WASHINGTON STATE DEPARTMENT OF TRANSPORTATION CHANGE ORDER

CONTRACT NO: 009674 FEDERAL AID NO: CONTRACT TITLE: SR 520, I5/MERCER ST TO SR 520/PORTAGE BAY 1-5 INT CHANGE ORDER NO: 99 PROJECT COMPLETION CLEAR ALL

This contract is revised as follows:

PLAN REF, NO.
PV17 SR 520 I-5/MERCER ST TO SR 520/PORTAGE BAY I-5 INTERCHANGE IMPROVEMENTS 394 872 SHEETS **PAVING DETAILS**

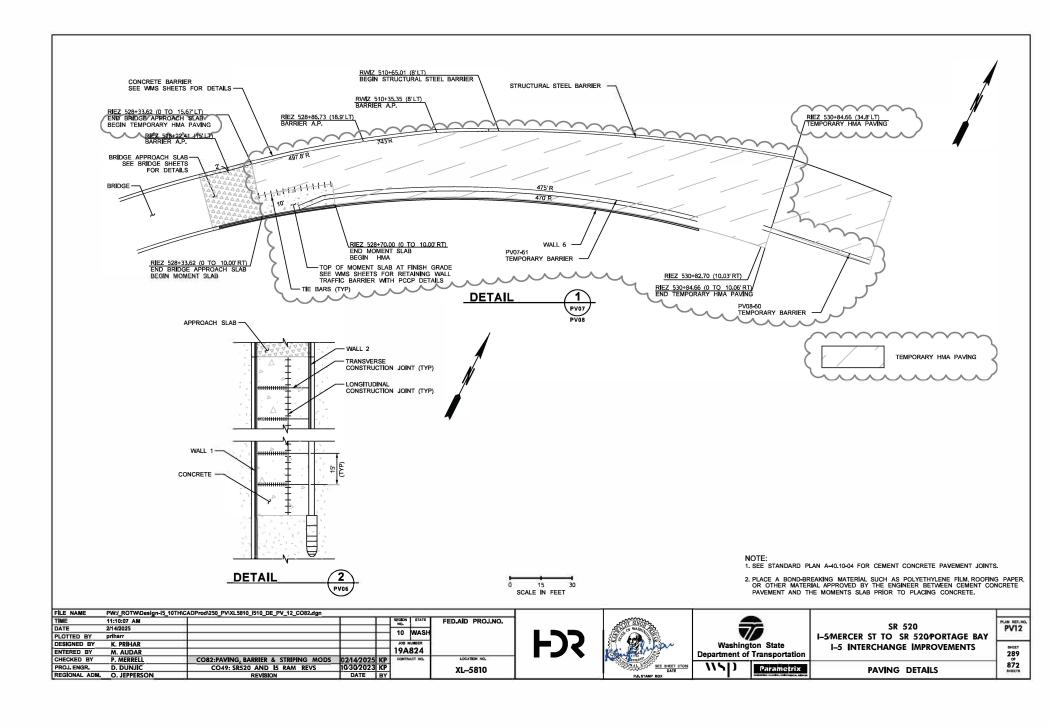
Modifications or elimination of Work associated with paving, barrier, and pavement marking along SR 520 and the intersection of SR 520 and I-5, as detailed herein.

Modifications to the embedded section of the transition between Precast Conc. Barrier Type F (PV05-51) to a Single Slope Barrier, 13" into the concrete, as detailed in the response to RFI 356 PV05-51 Precast Concrete Barrier Type F To Single Slope Transition, dated April 30, 2024.
